19 May 2017

Objection to Appeal (reference APP/X5210/W/3164577) at 28 Redington Road, London, NW3 7RB

Fig. 3.3.4 Width Between Buildings of neighbouring houses as proposed

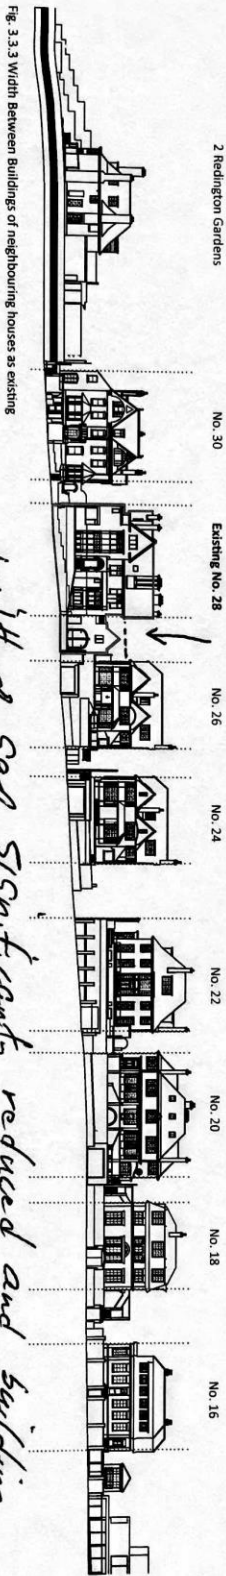
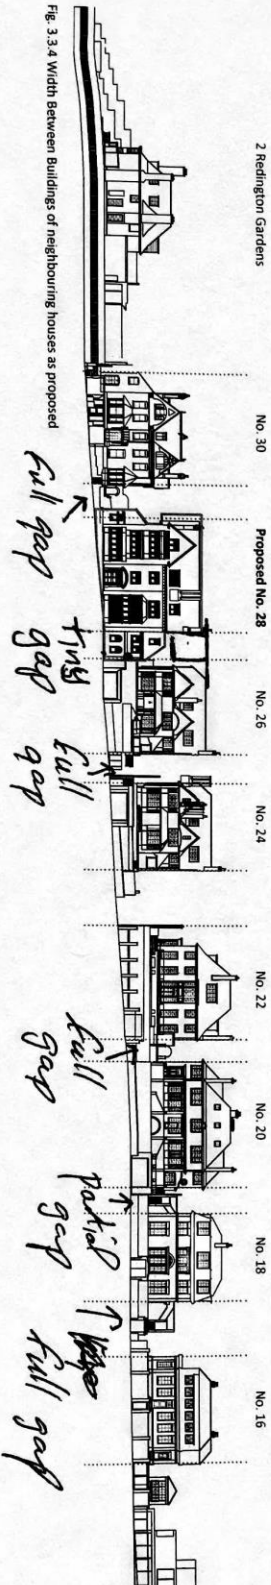
The Appellant's own Design & Access Statement (diagram on page 16) evidences that the gap between my home and 28 RR would be substantially decreased if the proposal is permitted. It is inserted below.

The proposal would significantly reduce the width of the gap, while also building in some of the gap currently above the garage building. As can be seen from the D&A, this would effectively leave a tiny square gap that would be by far the smallest in the row of houses.

Gap slightly wider than some others, but only "half height" due to building is between main houses

width of gap significantly reduced and building is between expanded, making overall gap "volume" much smaller than other gaps

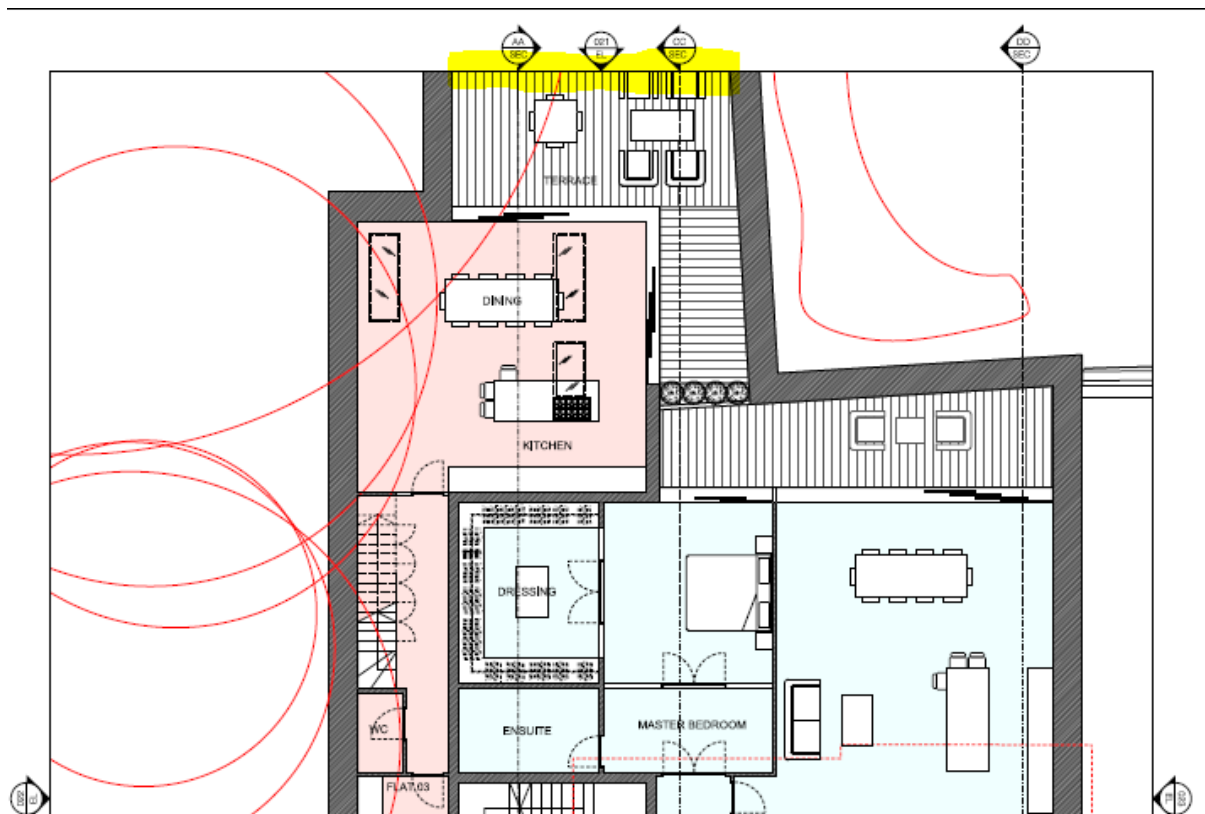
The proposed basement is substantial and is double depth at the rear of the property. Proposed Section AA (drawing number JCA-RR-PR-007 Rev PP4) shows that the rear of the property has two

basement levels below the level of the existing garden. In addition, there is a large lightwell deep into the garden and around the whole rear of the proposed property that provides both light and amenity space to the whole of one sub-terrarium flat and the living space of another.

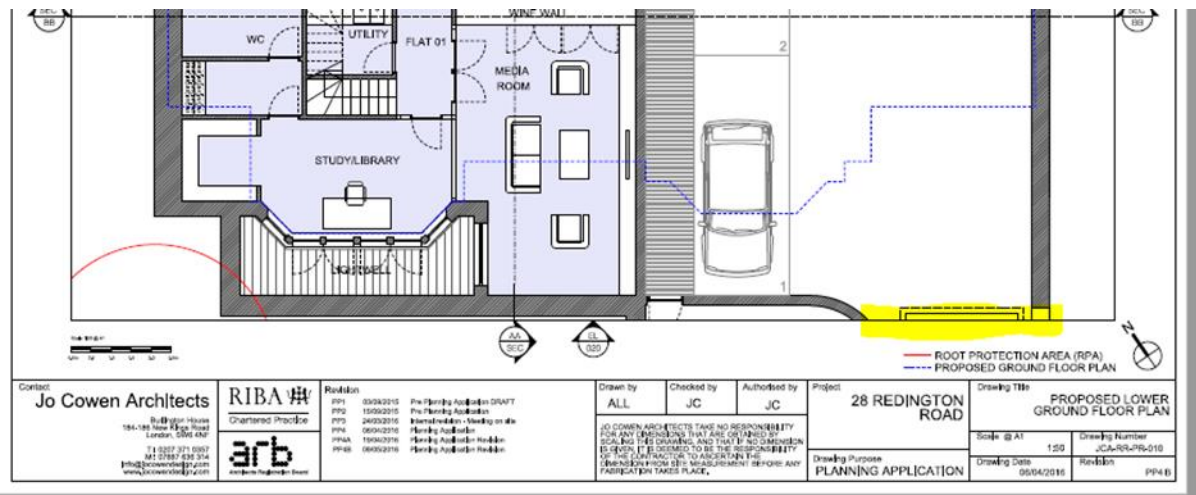
The floorplans are incomplete with elements of the proposed development not given on the plans The first level basement (called ground floor plan) shows the rear light well disappearing off the top of the page. It is only known that it extends further from Section AA. I have highlighted the error below.
